Technical Bulletin

Summary of issue: SpectrAlert® Advance Mini-horn – Inability to Silence

Model Numbers: MHR, MHW

4 digit
date code
location

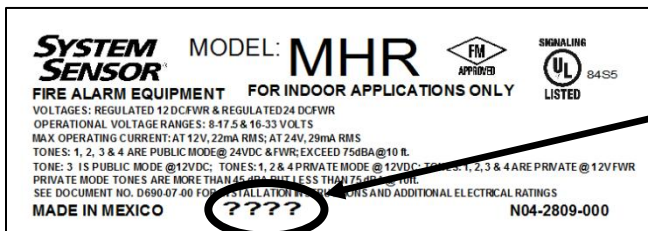
Manufactured date range: October 1 2014 (4101) to March 17 2015 (5033)

System Sensor has identified an issue with the Mini-horn models MHR and MHW when the silence feature is used. Products manufactured within the date codes specified above may not silence when the silence feature is activated on the Fire Alarm Control Panel. Date codes outside of this range are not affected.

This issue does not affect product performance for sounding and notification. System Sensor has implemented a change to correct this issue on date codes 5034 and beyond.

The commissioning, annual inspection, and testing of each Mini-horn must be conducted in the manner in which it was designed to operate as described in NFPA 72® and local AHJ requirements. Mini-horns that have been installed, tested and are not exhibiting this issue need not be replaced. If you are experiencing the condition described, System Sensor will honor its warranty return policy and is recommending that products exhibiting this issue within the date codes specified above be replaced and returned through normal channels.
